Work Order ID 72679

Item Name: Crosstube Aft

DRAWING NO. D212-664-241	TITLE CROSSTUBE ASS'Y (205/212 HI AFT)	REV. D	DART AEROSPACE LTD ENGINEERING ORDER		D.E.O. NO. D212-664-241-D-2	SHEET NO. SHEET 1 OF 1	SCALE NTS
DRAWN <i>97</i>	CHECKED <i>ASS</i>	MFG. APPR. <i>8</i>	APPROVED <i>MD</i>		DE APPR. <i>HA</i>		
DATE 11.07.15	DATE 11.07.20	DATE 11.07.21	DATE 11/07/21		DATE 11-07-21

DRAWING NO. D212-664-241	TITLE CROSSTUBE ASSY (205/212 HI AFT)	REV. D	DART AEROSPACE LTD ENGINEERING ORDER		D.E.O. NO. D212-664-241-D-1	SHEET NO. SHEET 1 OF 2	SCALE NTS
DRAWN	CHECKED	MFG. APPR.	APPROVED	DE APPR.			
DATE 11.04.07	DATE 11.04.11	DATE 11.04.12	DATE 11/04/12	DATE 11.04.12

**D212-664-241/-241B
ASSEMBLY DETAIL**

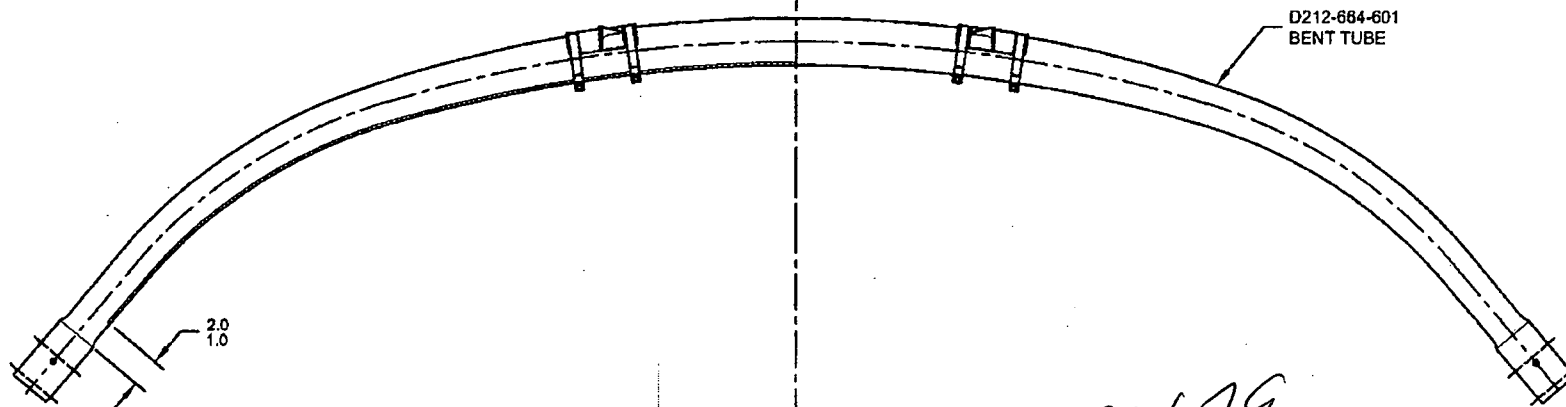
ADD AN INSPECTION WINDOW TO UNDERSIDE OF CROSSTUBE.

- 2) FINISH: CHEMICAL CONVERSION COAT PER DART QSI 005 4.1
PRIME INSIDE AND OUTSIDE PER DART QSI 005 4.2
MASK UNDERSIDE OF CROSSTUBE AS SHOWN (HATCHED AREA) AND
PAINT OUTSIDE PER DART QSI 005 4.2
REMOVE MASKING AND APPLY CLEAR COAT

- 2) FINISH: CHEMICAL CONVERSION COAT PER DART QSI 005 4.1
PRIME INSIDE AND OUTSIDE PER DART QSI 005 4.2
PAINT OUTSIDE PER DART QSI 005 4.2

MASK AREA PRIOR TO PAINTING,
REMOVE MASKING AFTER PAINT
AND APPLY CLEAR COAT
